**G-12502
March 2012**

SUBJECT: SAFETY RECALL

Bendix ATR-6 valve on certain CE-C and HC bus models and DuraStar[®], PayStar[®], WorkStar[®], TransStar[®], LoneStar[®], and ProStar[®] model trucks built 12/02/2010 thru 01/26/2012 with traction control or stability control.

FIGURE 1 - BENDIX® ATR-6™ TRACTION RELAY VALVE

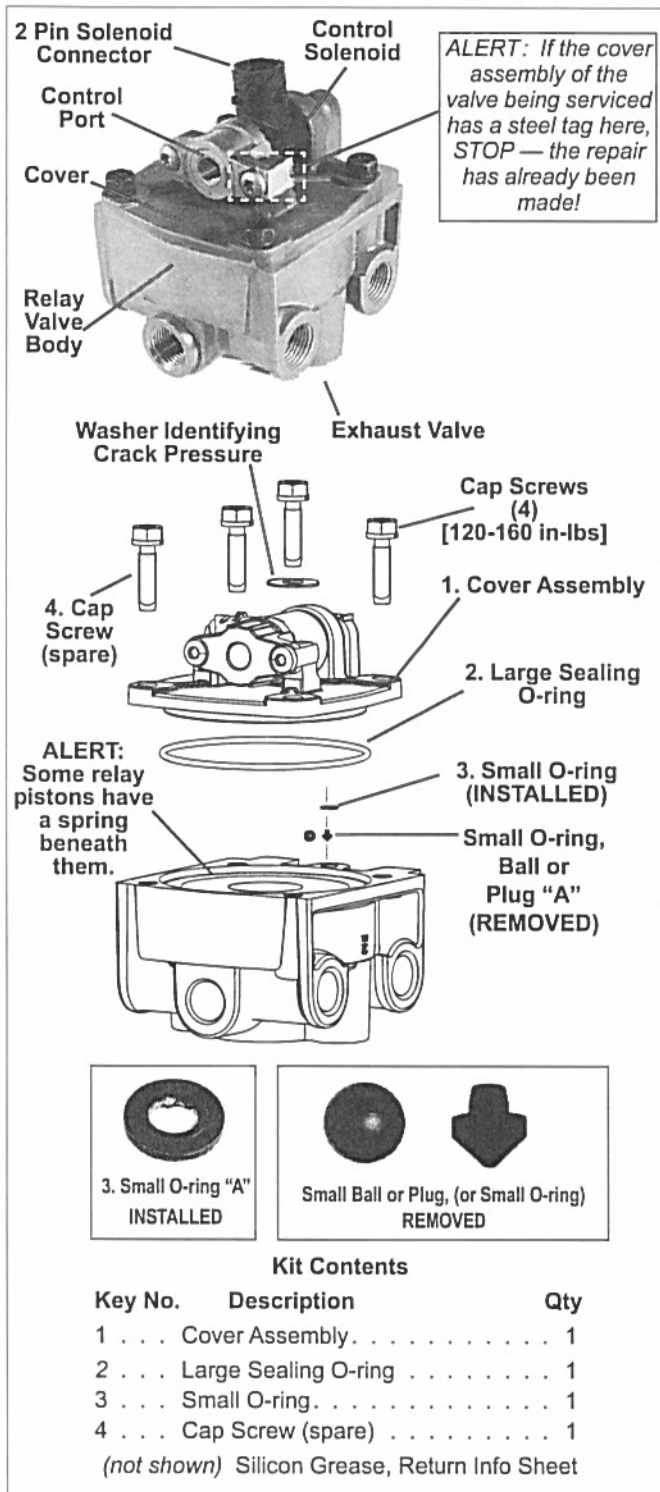
1. Verify that the Bendix® ATR-6™ valve does not have the steel tag (See Figure 1) that indicates it has already been serviced.
2. **Clean the valve and take care to avoid any contamination inside the valve during these procedures.**

6. • **Remove and discard the ball or plug (“A” in Figure 1) from between the cover and the valve, OR,**
• For ATR-6 valves that have not been serviced by a temporary disable kit, there will not be a ball or plug; **remove and discard the original small O-ring.**

7. Remove and discard the large sealing O-ring.
8. Grease and install the new large sealing O-ring (2) and the small O-ring (3) supplied, into the NEW valve cover.
